From: Oswald, Hank
Sent: Thursday, September 21, 2017 1:27 PM
To: 'Charles Combs'
Subject: RE: 2525 Sand Hill Rd Septic Easement

APPLER PROPERTY
THIRD ELECTION DISTRICT
HOWARD COUNTY, MARYLAND
SCALE: 1"=100'
FEBRUARY, 1977

PLOT PLAN
2525 Sandhill Road
Appler Property, Lot
Plat No. 3700

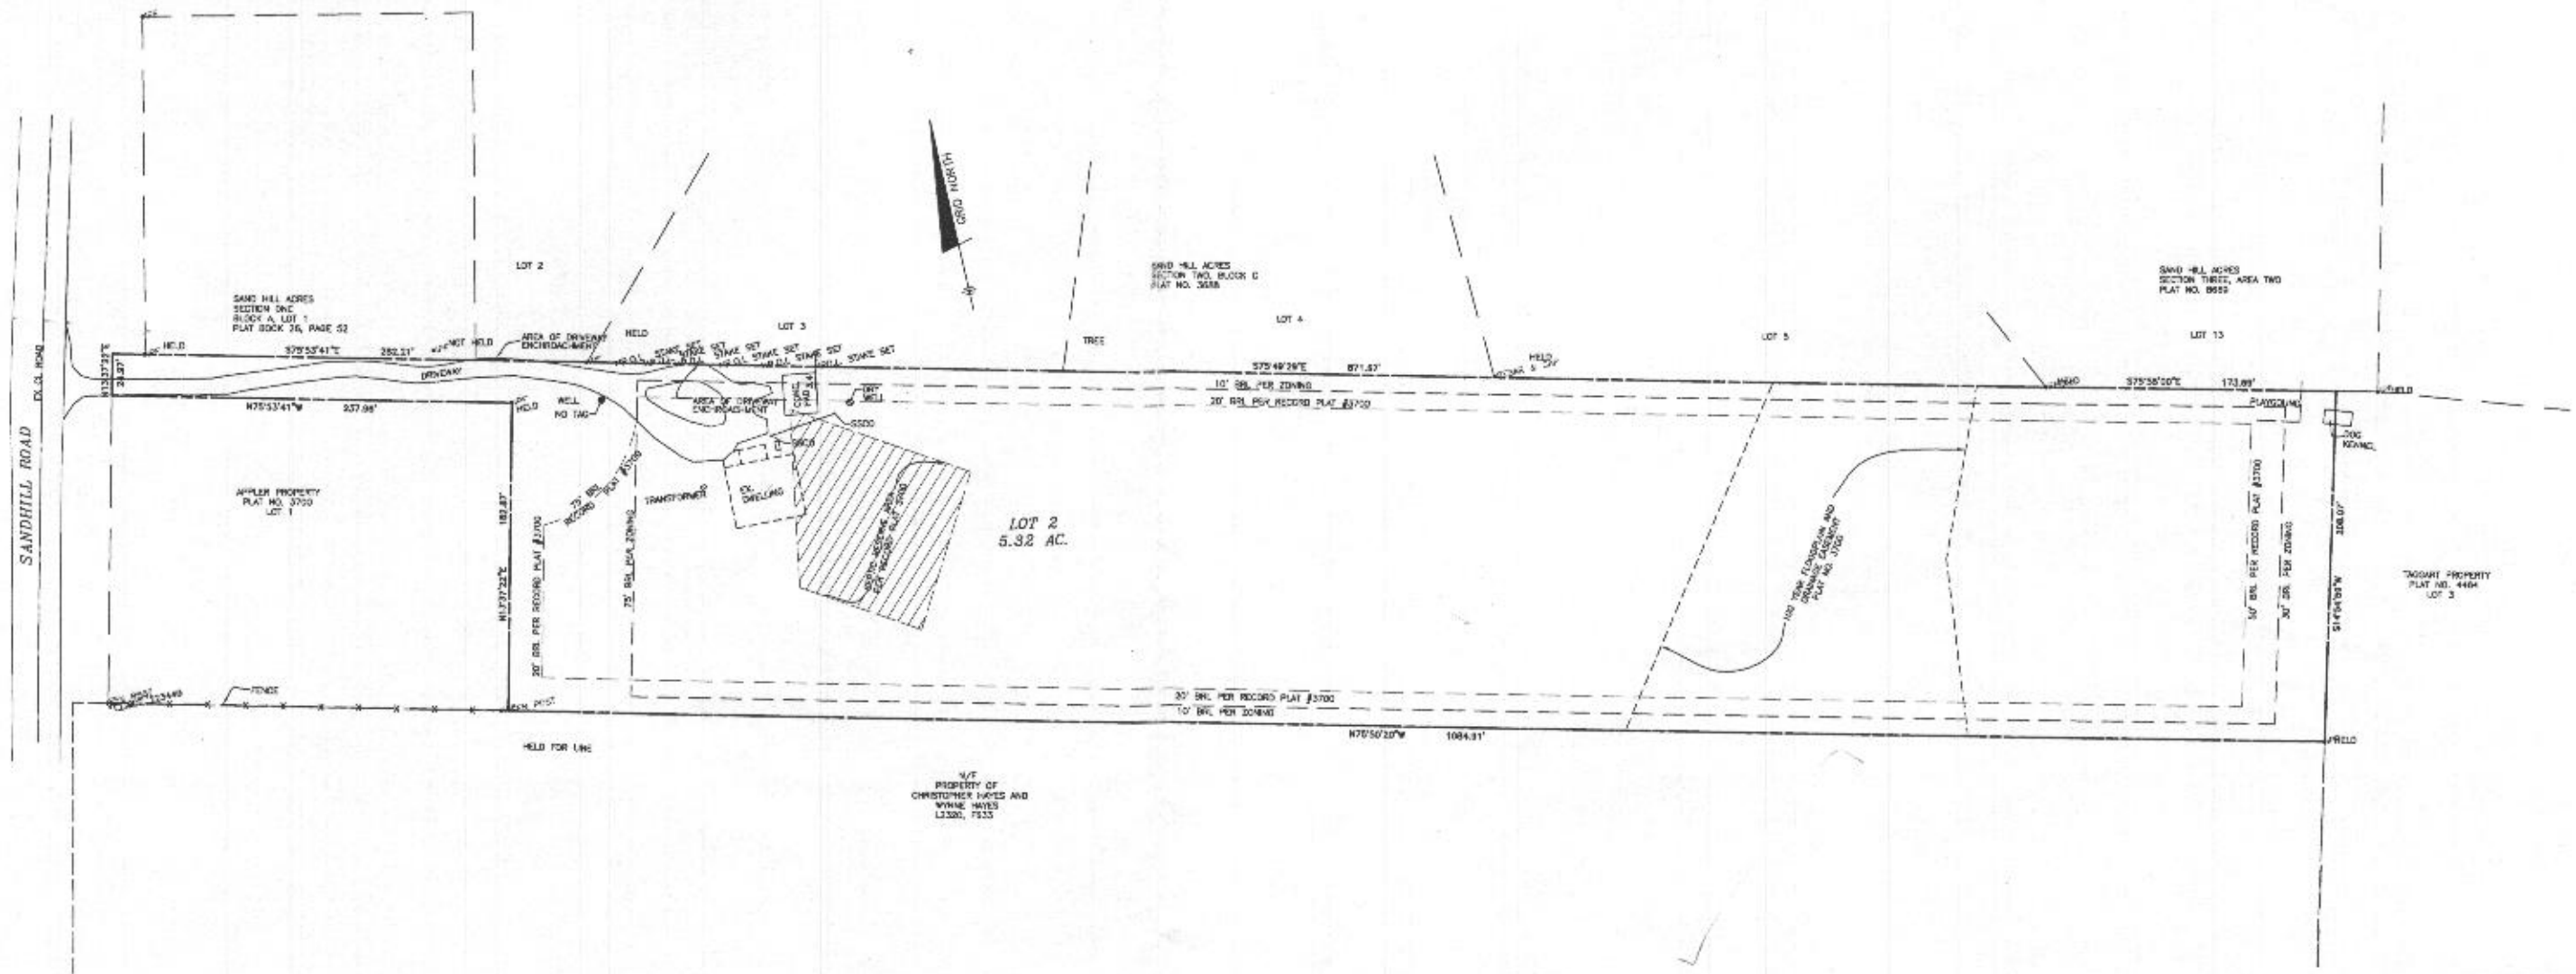
We would not approve anything that would take up more space within the SDA than the existing concrete pad. I hope that helps. With that said, propose something and I will get back to you with an answer but make sure you add in the septic tank and trench locations to the plan.

I've attached a signed plat detailing the location of the sewage disposal area. Without a percolation certification plan, it's hard to tell where exactly the perc test holes are located and I don't think the septic record provides enough details. It seems as you go down the hill in the back, the perc test results get worse.

I have a few follow-up questions. Are the septic components plotted correctly on the plan because the tank location alone does not seem to match up with the As Built drawing (attached). Also, the plan does not show the existing trench. Are you planning to build on top of the existing concrete pad or expand on the foot print? The concrete pad is within the 20 foot BRL so you may want to consult with Planning and Zoning on location of proposed garage before you go any further with this plan.

Does the location of the easement look correct? With a 20 foot setback the house shouldn't be hitting it.

Also, with a 20 foot setback requirement, there doesn't appear to be any space for a garage in the vicinity of the concrete pad. What is your take on that?

1. The SSCO are correct. They are where the cleanouts are. The one near the house is where the tank is. That rectangle near the house is an old deck footing. The tank isn't actually shown.
2. My intent is to replace the pad with a garage, the exact placement of which depends on what we can do with the existing septic, but there is no way to meet the setbacks.
3. Understood that I need to get a zoning variance. I wanted to figure out where the garage would go first based on the septic requirements.
